**Nominal lateral load of the stiffener due to shear stress
in 6/3.4.2.2 in CSR BC Rules**

Lloyd's Register
Yokohama DSO
01/09/2009

Fig.1

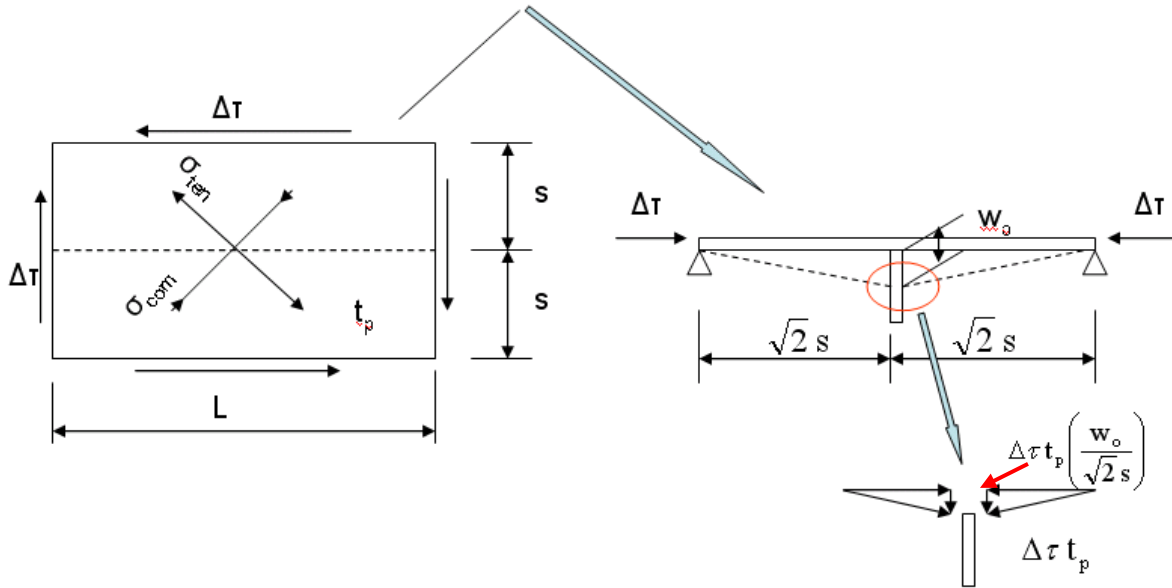
- a) When the shear stress τ is greater than the critical stress τ_{cr} of the plate panel of $L \times (2s)$, fitting of a stiffener is required to ensure its sufficient strength.
- b) The portion of the shear stress exceeding the critical value, i.e., $\Delta\tau = \tau - \tau_{cr}$, contributes to create the bending moment due to existence of the initial deflection.

The shear stresses $\Delta\tau$ are expressed by the principal stresses σ_{ten} and σ_{com} , i.e.,

$$\Delta\tau = \frac{1}{2}(\sigma_{ten} - \sigma_{com}) \quad \text{and} \quad \sigma_{ten} = -\sigma_{com} \quad (4)$$

Fig.2

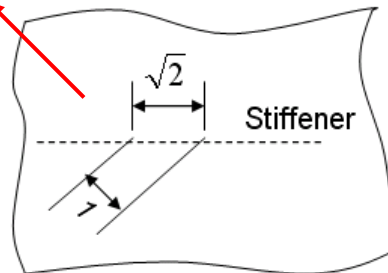
It is noted that the effect of tensile principal stress σ_{ten} is neglected in the Rules. Then a sinusoidal lateral load working downwards along the stiffener is obtained as follows:

$$q_s = 2\Delta\tau t_p \frac{w_0}{\sqrt{2}s} \left(\frac{1}{\sqrt{2}} \right) = \Delta\tau \frac{t_p}{s} w_0 \quad (6)$$

Here it is noted that eq.(8) does not consider Fig.2 and it results in the difference between eq.(7) and (8).

3. Considering the above, it is concluded that nominal lateral load of the stiffener due to s_x , s_y and τ_1 for longitudinal stiffeners in 6/3.4.2.2 should be modified to:

$$p_z = \frac{t_a}{b} \left\{ \sigma_{xl} \left(\frac{\pi b}{a} \right)^2 + 2c_y \sigma_y + \tau_1 \right\} \quad (9)$$

And that for transverse stiffeners also should be modified in the same manner.
